Change Order #6 Dicker Road

Project: Dicker Road
Project #: STP 1902 (383) MM
Contract: C-19-017-11-05
CSJ: 0921-02-312
Limits: Spur 115 (23rd Street) to FM 2061 (Jackson Road)

Change Order #6 includes two pavement re-evaluations performed by TEDSI to modify the final pavement and the temporary detour pavement design. It includes plan and quantity modifications for missing items and quantity adjustment for errors within the plans. It also includes an item to modify the Item 341 asphalt bonus and penalties.

DICKER ROAD
TRAFFIC CONTROL PLAN
PROPOSED TYPICAL SECTION
PHASE I,
PHASE II AND PHASE III

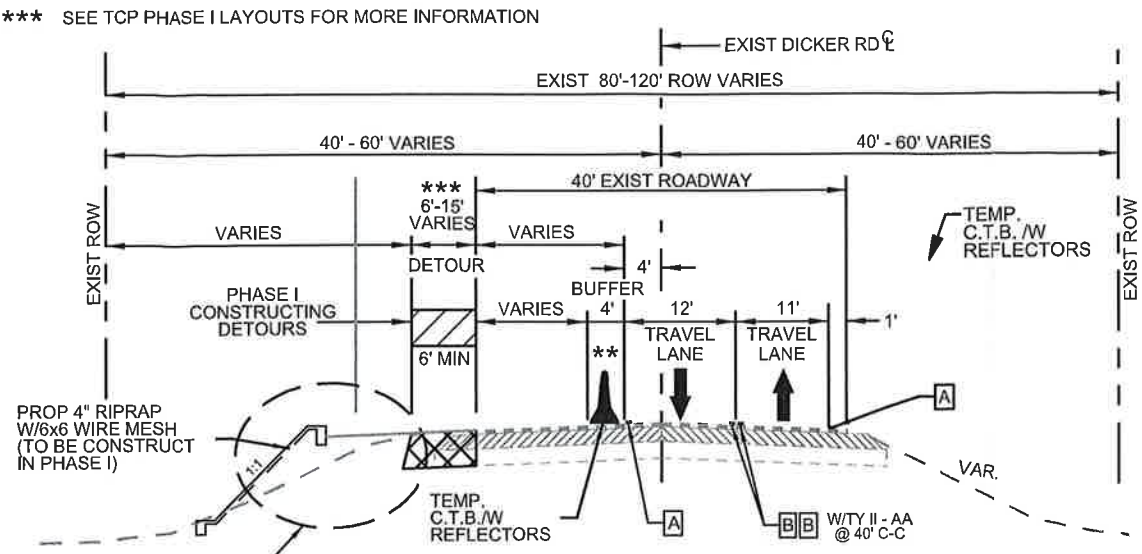
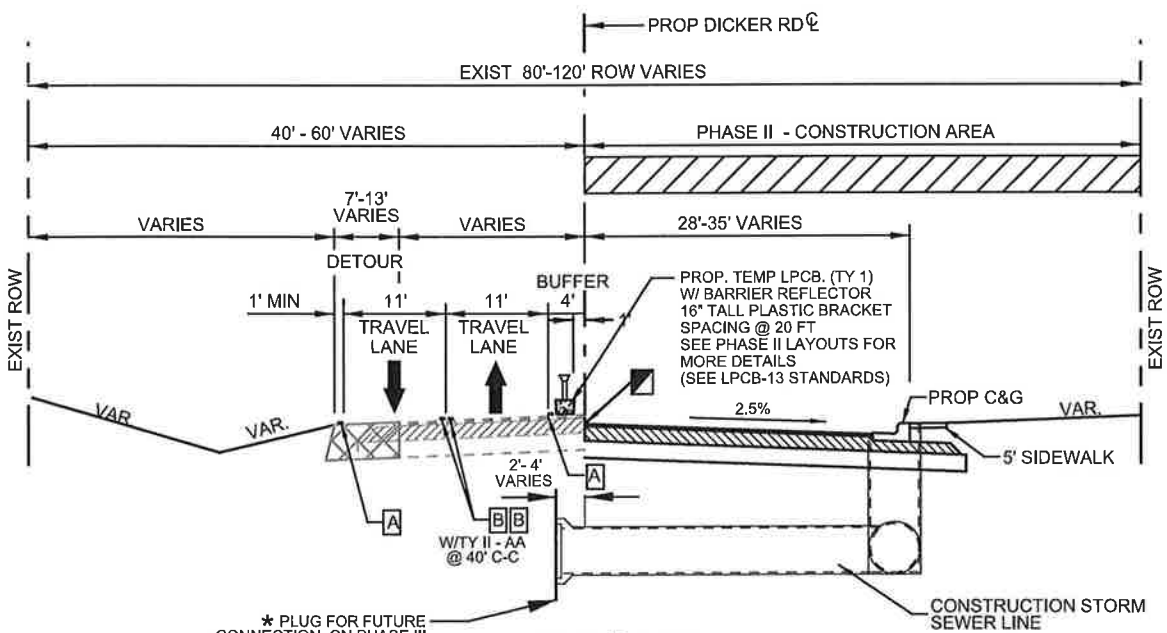
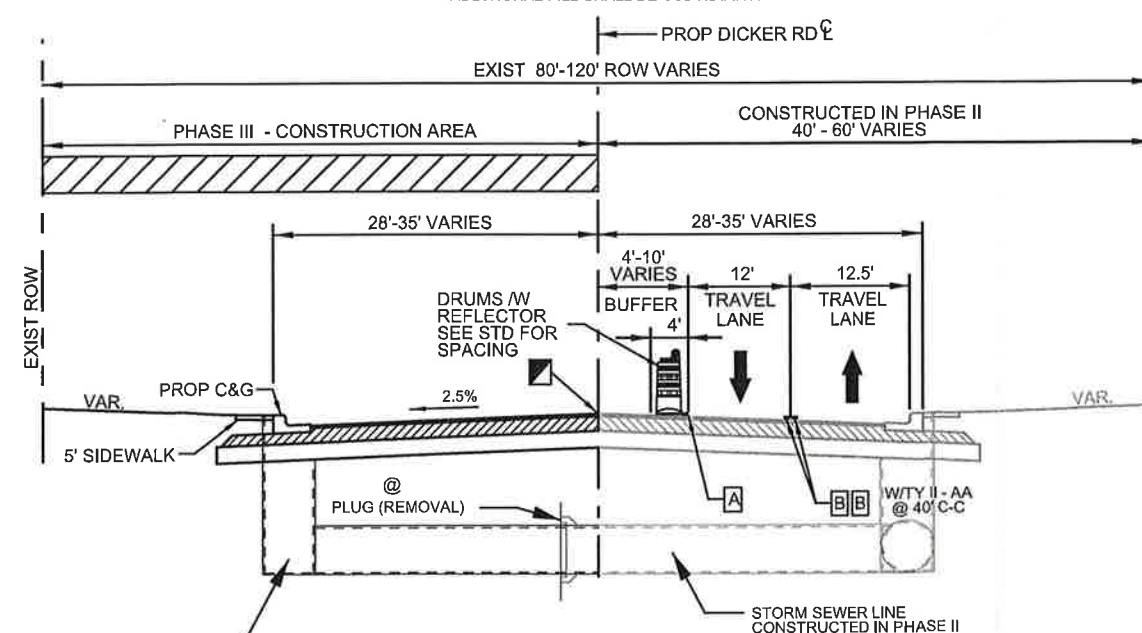
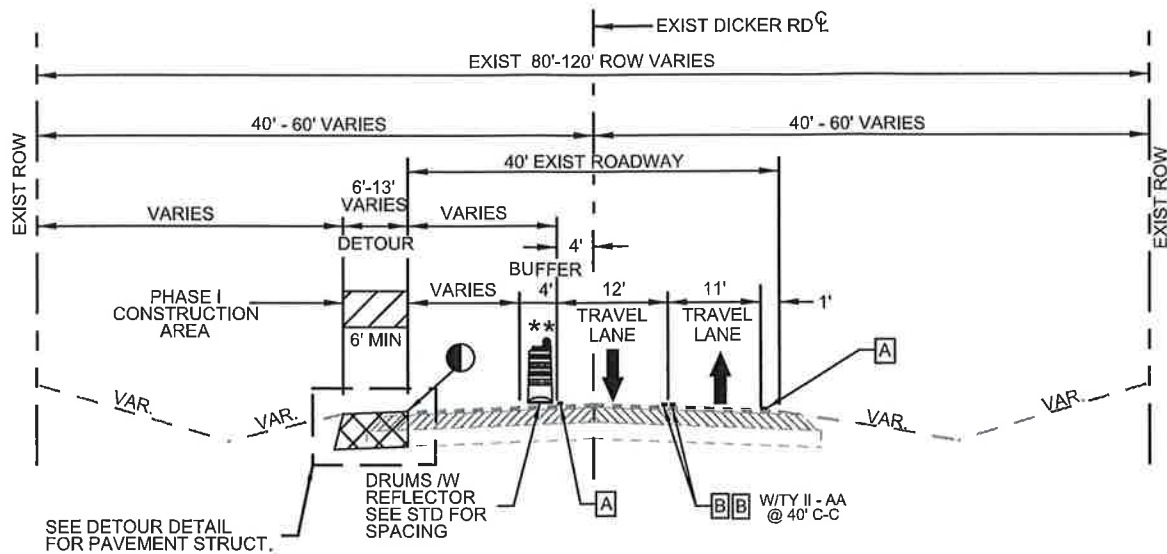
CO#6 - TEMPORARY PAVEMENT REPLACE (TY A)(GR 1) BASE WITH (TY E)(GR 4)

The project was designed with a temporary detour widening the length of the project to reconstruct Dicker Road in three phases. It was unusual that the detour was designed with a flex base (Ty A, Gr1) (limestone), when the final roadway used a different base (Ty E Gr 4) (caliche), which is a locally produced material. Hidalgo County Precinct #2 request for TEDSI to modify the base material and reanalyze the detour design for another valued engineering opportunity. The locally

produced material (caliche) reduces the detour item price from \$44.31/Sy to \$38.34/Sy. See Table A & Attachment B for details.

DICKER ROAD
 REMOVAL LAYOUT
 STA. 82+00 TO STA. 106+00

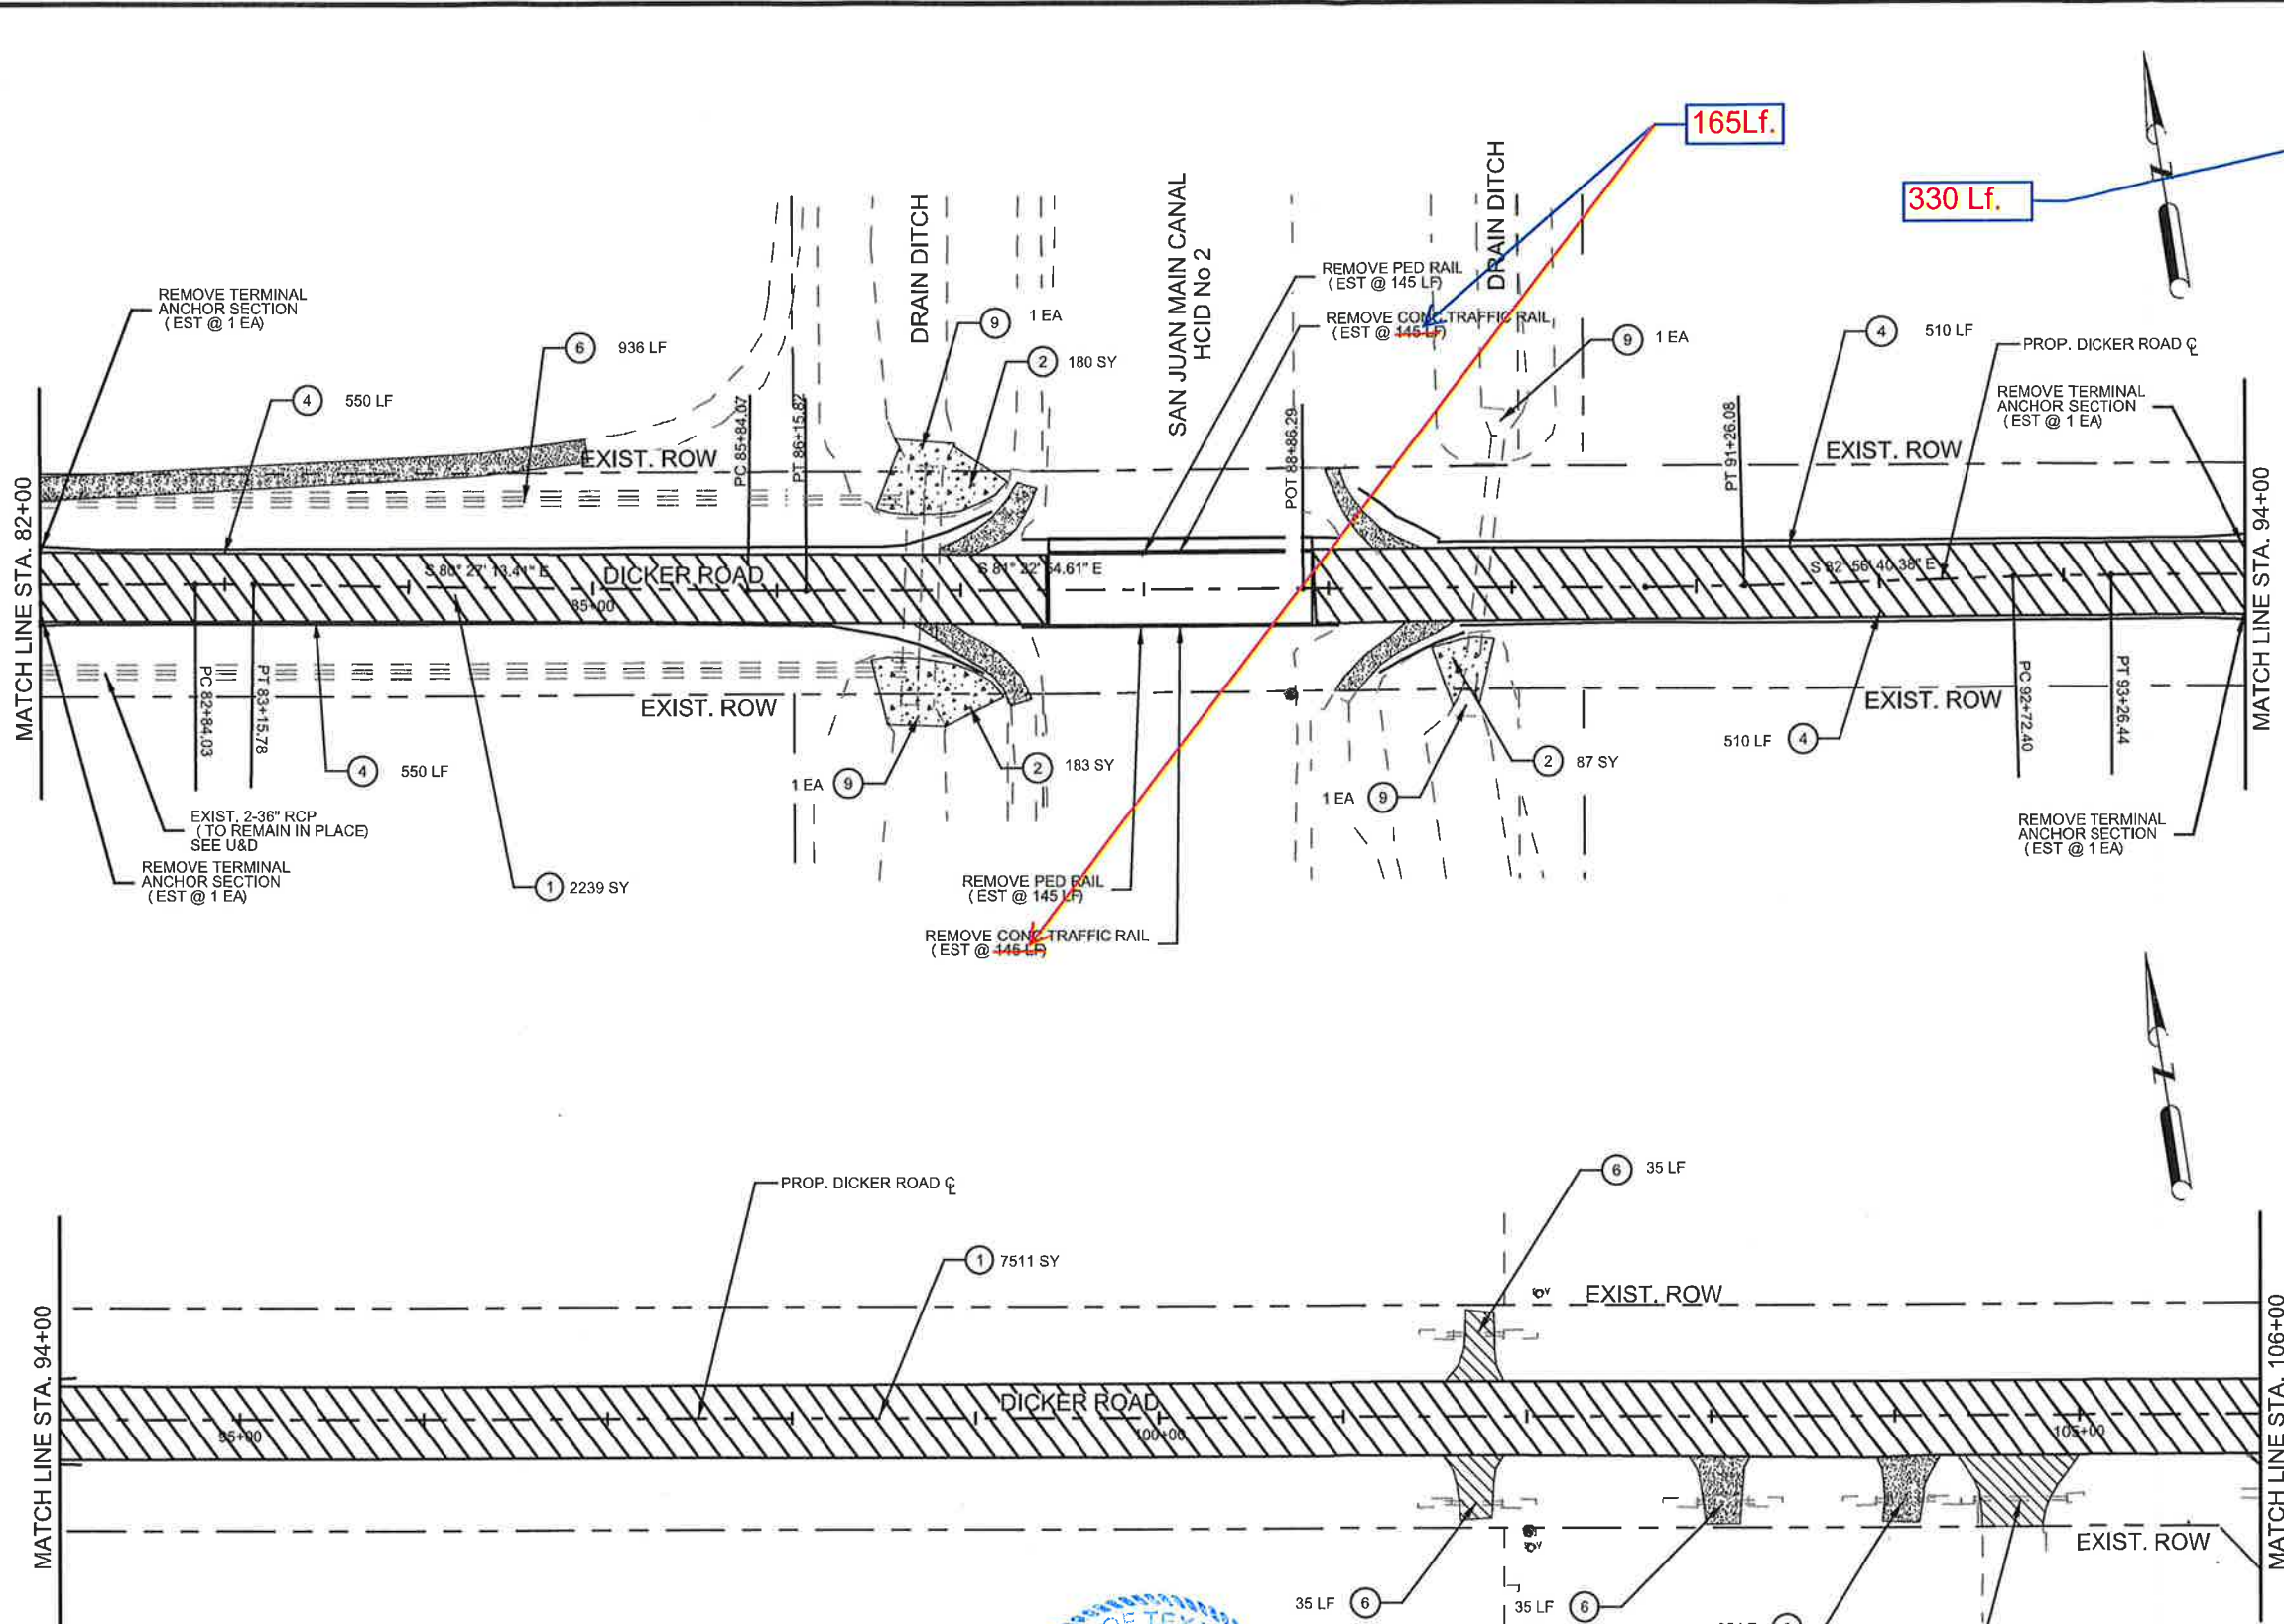
- Deduct 100 feet, "Metal Beam Guard Fence" (MBGF) - Replaced by the 2 SGT's above.
- Add 4 each, "Remove Structure, Wingwalls" at the same Sta 131+00. Plan sheet #**311a** was modified to include the changes.
- Add 80 feet, "Remove Concrete (Rail)" at Sta 88+00 and Sta 131+00. Plan sheets #**309a** & **311a** were modified to include the changes.

CO #6 -
 1st - Pavement, Reduce Ty "B" thickness to 4"
 2nd-Detour, Replace the (Ty A)(Gr 1) base with (Ty E)(Gr 4) base.
 3rd - Remove existing wingwalls, and railing

DICKER ROAD
 REMOVAL LAYOUT
 STA. 130+00 TO STA. 149+60.07

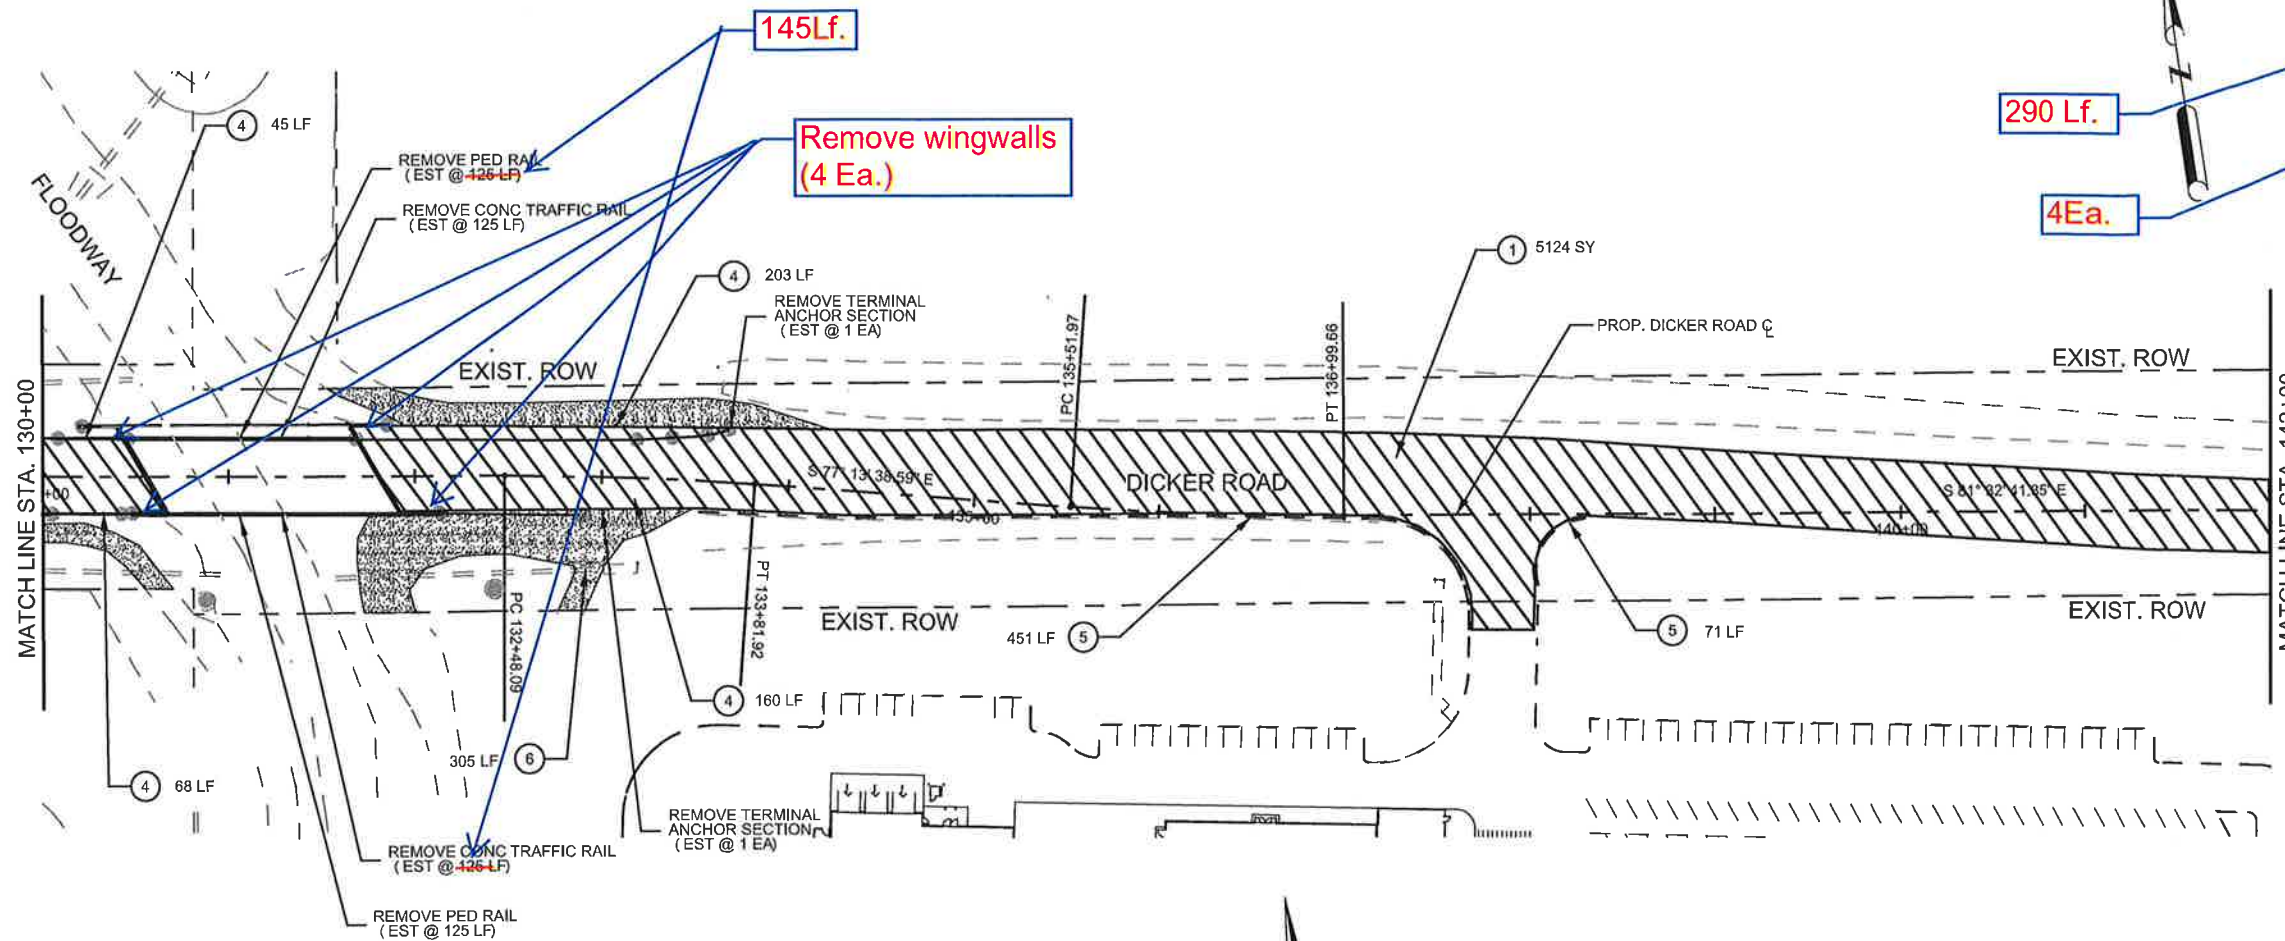
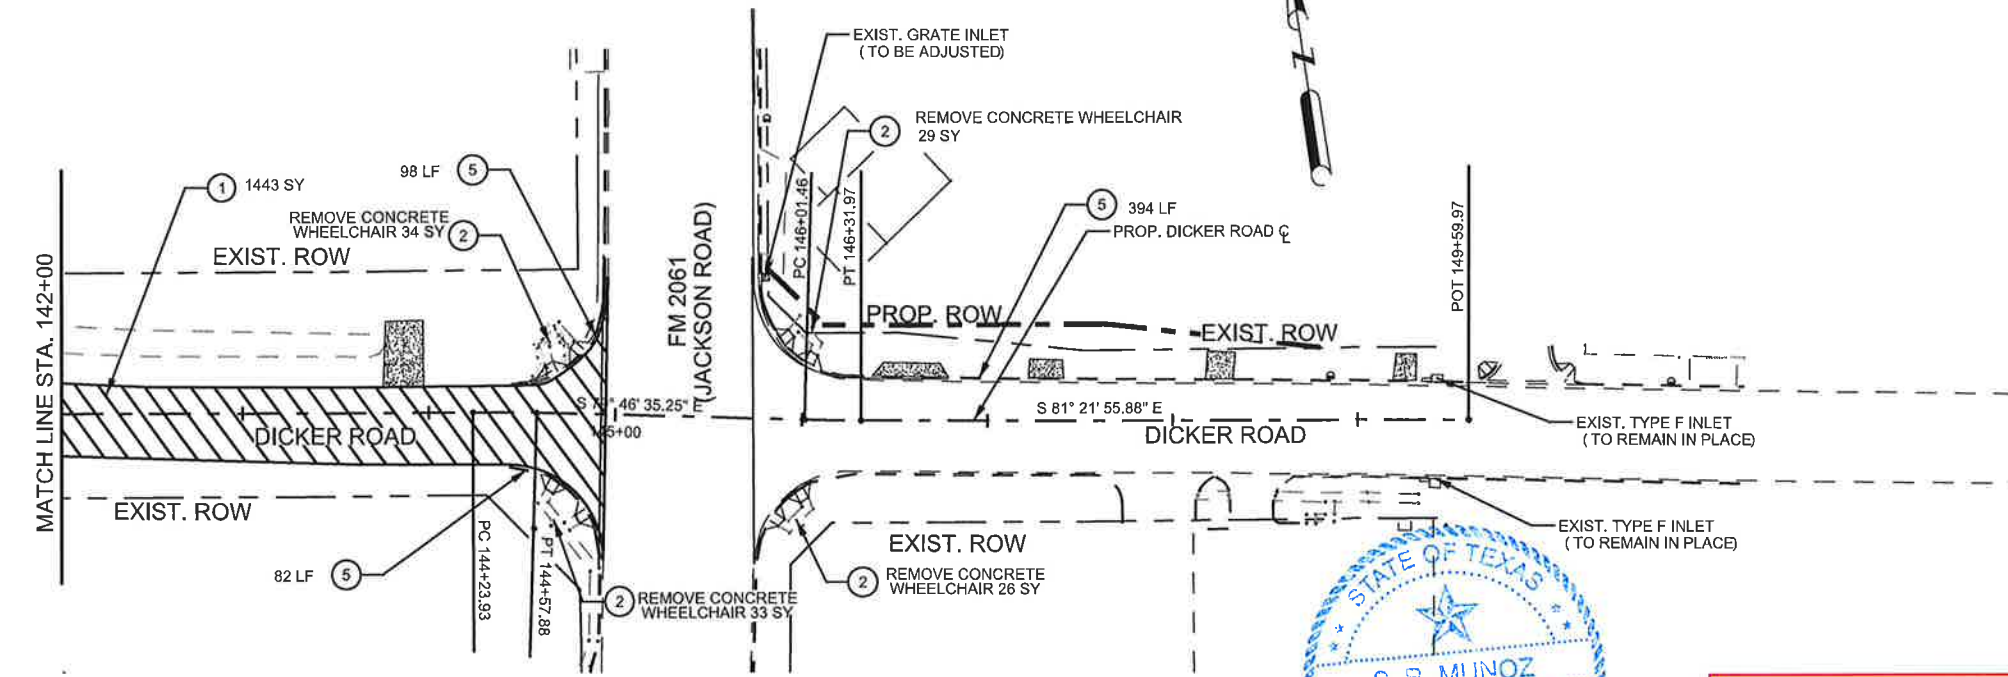
CO #6 -
1st - Pavement, Reduce Ty "B" thickness to 4"
2nd-Detour, Replace the (Ty A)(Gr 1) base with (Ty E)(Gr 4) base.
3rd - Remove existing wingwalls, and railing

Figure 1 – Proposed Typical Section Including the Specified 1/2-Inch Step

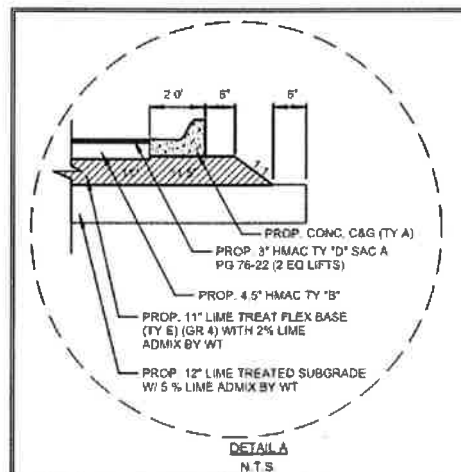
Our scope of services also included the evaluation of an alternative permanent pavement design section to eliminate the specified 1/2-inch step on the flexible base material located between the asphaltic flexible pavement section and the concrete curb and gutter structure (please refer to the Figure 1 for the curb and gutter detail).

For a 20-year design period and in order to eliminate the specified 1/2-inch step between the asphalt pavement section and the concrete curb, the resulting flexible pavement design, consisting of a 30-inch thick flexible pavement section (from surface to subgrade) is summarized below:

Please note that the thickness of the FBM layer beneath the concrete curb must match the thickness of the FBM layer of the selected asphalt pavement section in order to eliminate the step included in the specified typical section. Also, it is our judgment that a credit should be given to the County of Hidalgo, Precinct 2, in response to the reduction of 1/2 inch hot-mix asphaltic concrete and the elimination of lime-treated flexible base material consisting of Item 247, Type A, Grade 1 or 2 (treated with 2% lime by weight), and replacing it with 11 inches of lime-treated caliche flexible base material meeting the TxDOT Item 247, Flexible Base, Type E, Grade 4 specifications. Further, we understand that the TxDOT's Pharr District has been treating the flexible base material with cement instead of lime. It may be beneficial to conduct a cost analysis and confirm if the cost savings are sufficient to replace treatment of the flexible base material with cement instead of lime.
